CHAPTER 9. CLARIFICATIONS AND REVISIONS TO THE DRAFT EIR

9.1 Introduction

9.2 Clarifications and Revisions

Figure 2.4-1. Existing Site Plan

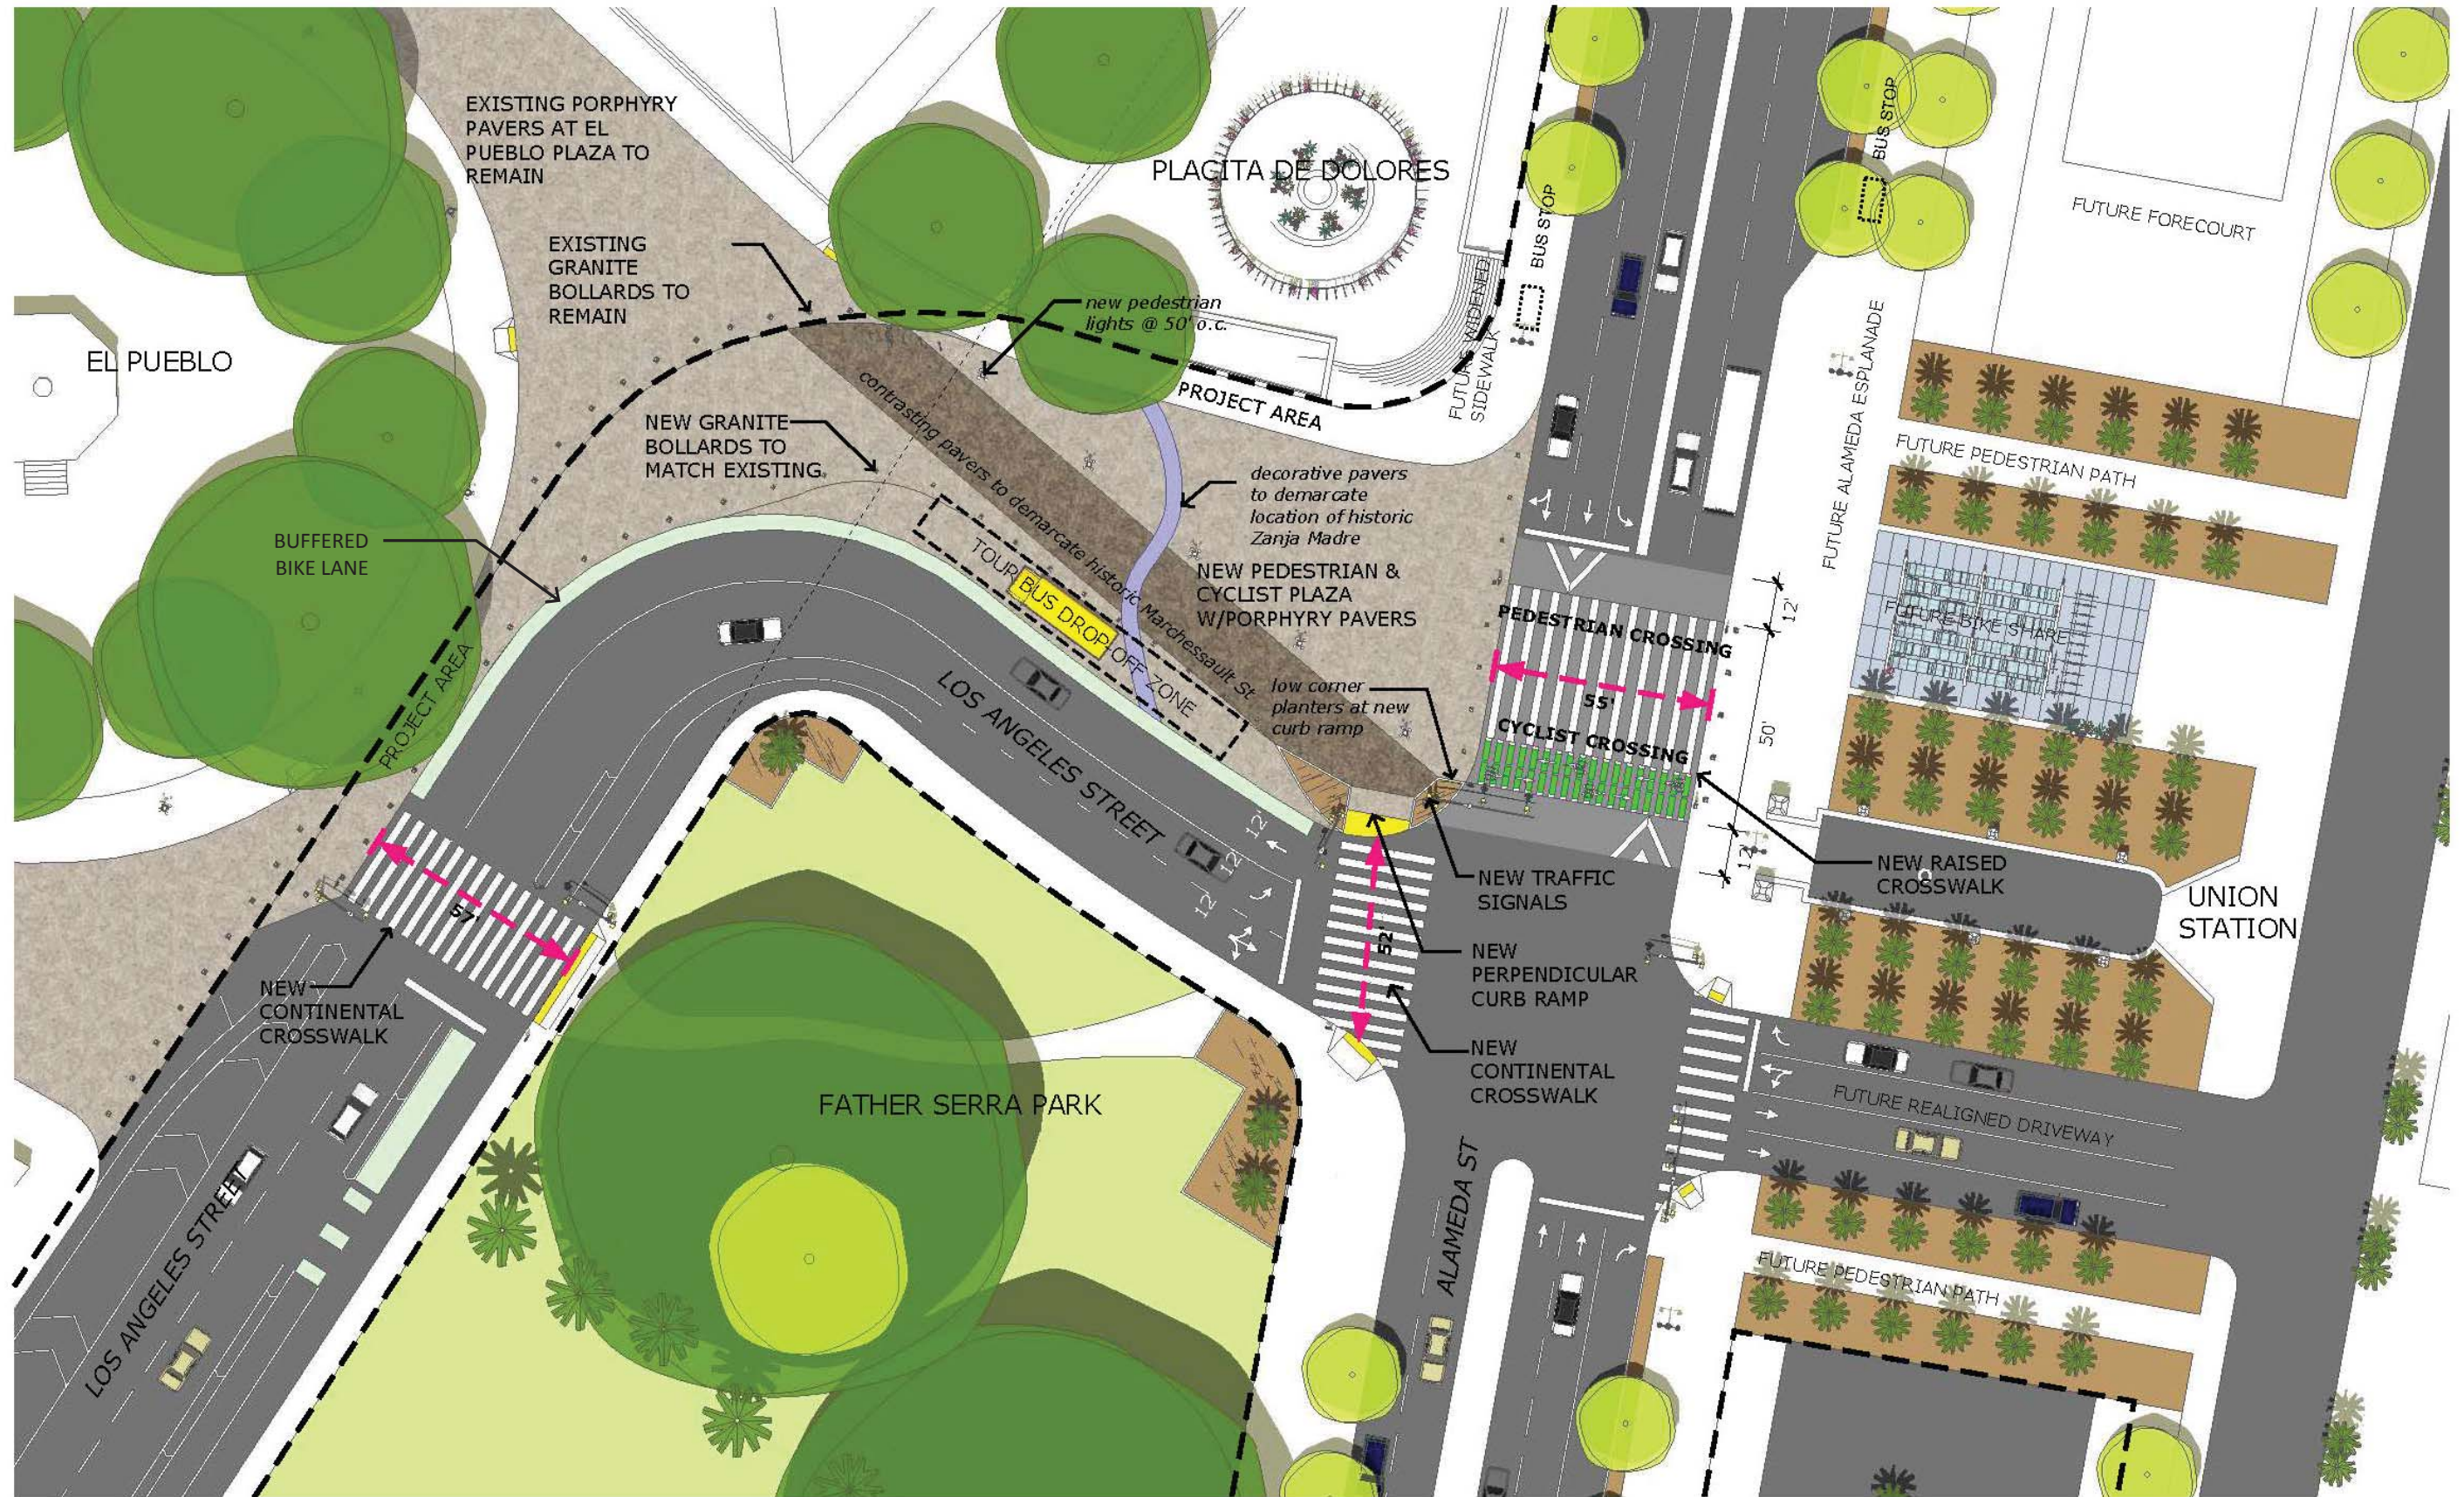
Page 2-6: Figure 2.4-1, *Existing Site Plan*, following this page, has been revised to show the dimensions of the existing buffered bicycle lane.

Figure 2.4-2. Project Plan

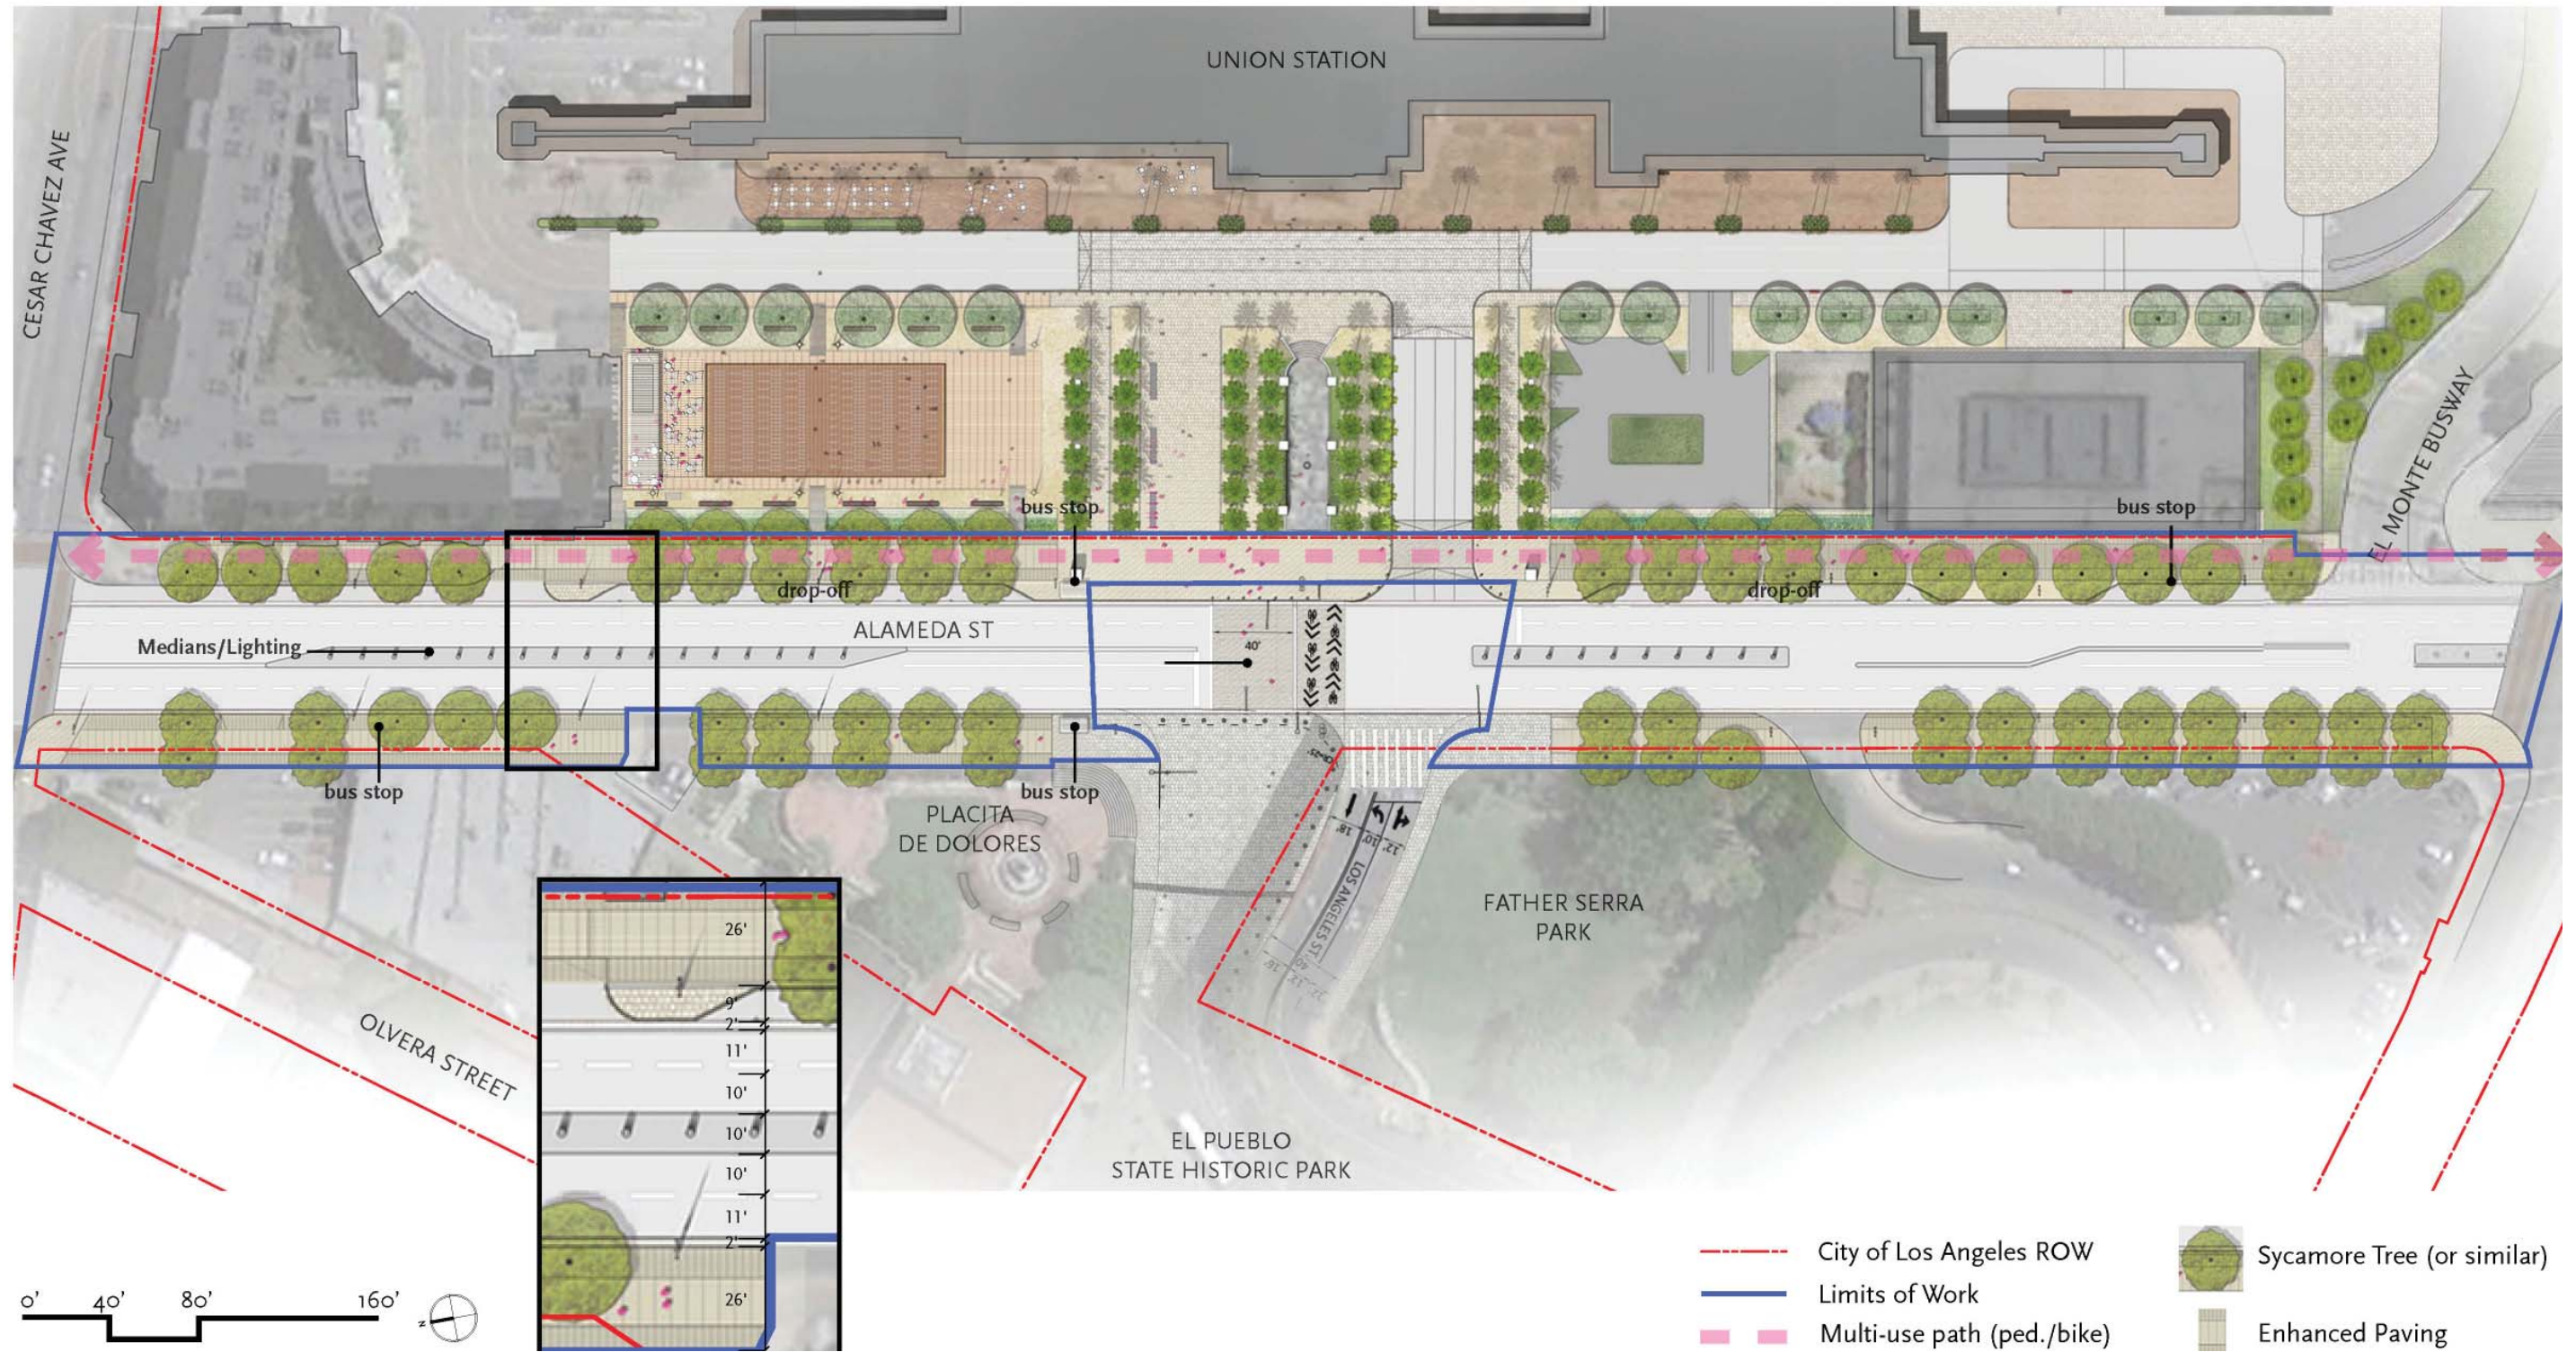
Page 2-6: Figure 2.4-2, *Project Plan*, following this page, has been revised to include a callout to the buffered bike lane.

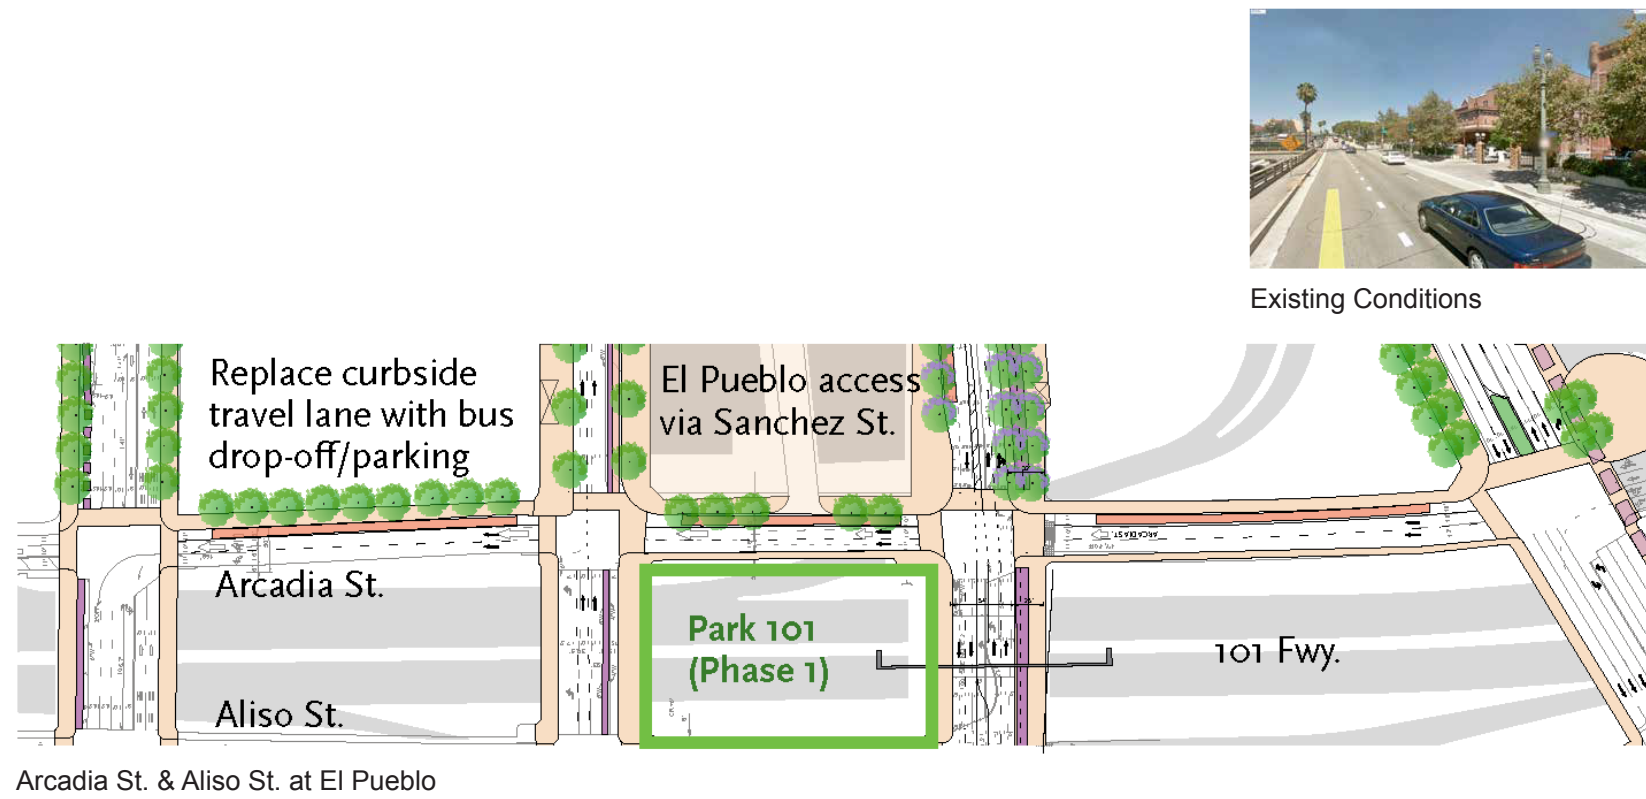
Page 2-8: A new figure, Figure 2.4-4, *Arcadia Street*, following this page, has been added to provide clarity on the project elements along Arcadia Street.

The existing ~~easternmost~~ northernmost travel lane on Arcadia Street westbound between Alameda Street and Spring Street would be used as a tourist bus parking zone designated for El Pueblo (Figure 2.4-4, Arcadia Street).
